# Public consultation on the high-level approach for the identification of alternative bidding zone configurations to be considered for the bidding zone review

Figure 1 – High-level approach for the definition of alternative BZ configurations

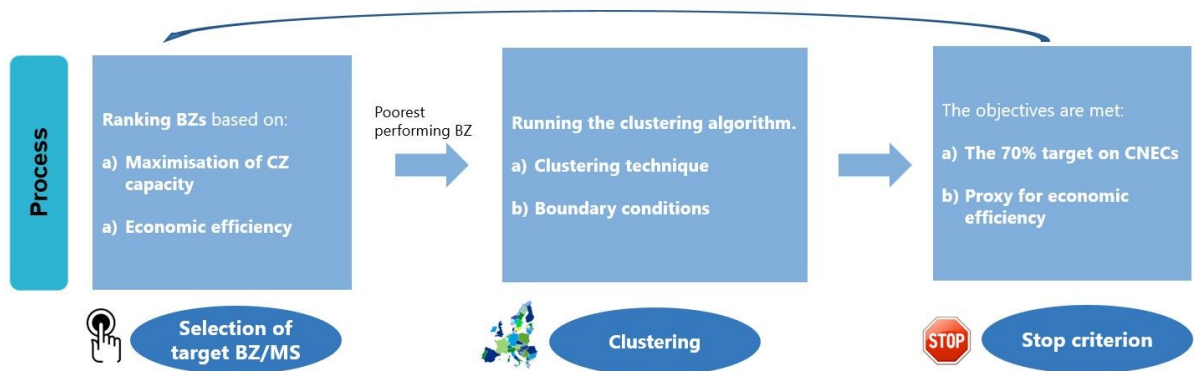
The approach proposed by ACER of how to arrive at the alternative bidding zone configurations is not fully clear, so it is difficult to provide detailed feedback on it. We understand that iterations are performed until the stop criteria are met. This would lead to only one 'high potential' alternative bidding zone configuration necessary to reach the stop criteria. This scenario will contain a certain number of changes compared to the status quo. Then choosing to test another configuration with only a subset of the changes of this 'high potential' configuration seems arbitrary and inherently means that this configuration does not comply with all the stop criteria. Alternatively, to obtain another 'high potential' configuration, the 70% target (stop criterion a) could be relaxed, to e.g. account for remedial actions. This way the whole region under consideration would be compliant with the stop criteria which would be varied to take into consideration different uncertainties.
